# Product Change Notification

## 113607 - 00

**Change Notification #:** 113607 - 00  
**Change Title:** Intel® Server Chassis P4308XXMFEN  
PCN 113607-00, Product Design, Label  
Update Hard Disk Drive Tray to add 2  
latches and labels, and Update Regulatory  
Labels  
**Date of Publication:** January 26, 2015

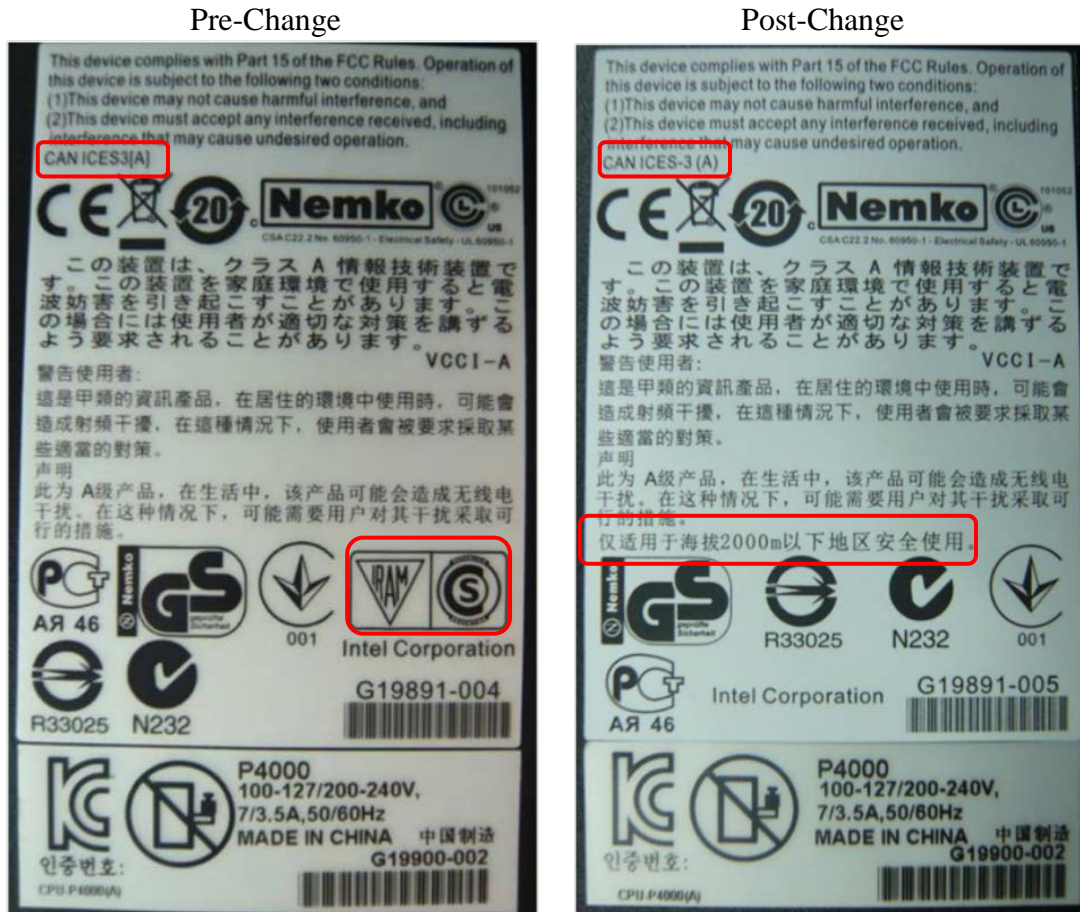
1. Add two latches and labels for the fixed HDD (Hard Disk Drive) tray to enhance the robustness of the HDD tray and indicate the touch point for the HDD tray assembly.
